Brewhouse Part VIII Amendments

Proposed Part VIII Amendments

October 2017

P114-215K Brewhouse

SOUTH ELEVATION PROPOSED AMENDMENTS

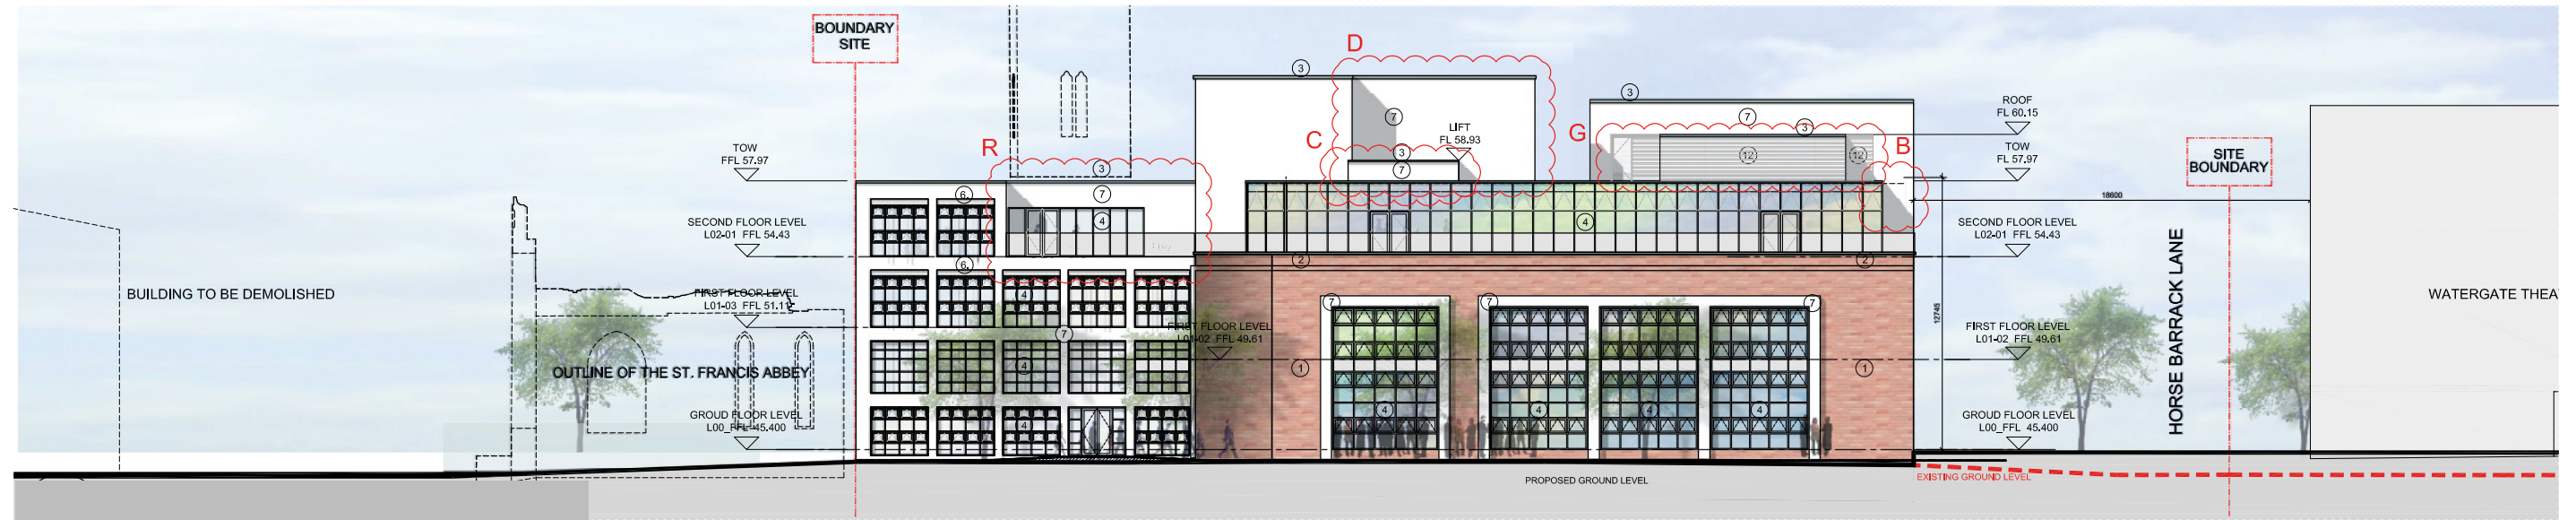
- A. Roof Heights and Levels Modified.
- B. Balcony Modified, Roof Overhang Omitted.
- C. Lift Moved to New Location.
- D. Existing 'L' profile of Plantroom Reinstalled.
- E. Platform to Accommodate Equipment, Screened with Metal Cladding.
- F. Roof Light Modified.
- G. Sawtooth Roof Modified.

- H. ESB Substation Relocated. Bay Recessed 1m into Facade.
- J. External Landscape Levels Modified.
- K. Window Removed.
- L. Door added.
- M. Existing Floor Retained. Floor Level Modified.
- N. Water Tank Screened Behind Sawtooth Roof Structure.
- P. Facade Updated to Reflect Existing Column Grid Structure.
- Q. Facade Updated to Reflect Internal WC Core Modifications.
- R. External Balcony Modified.
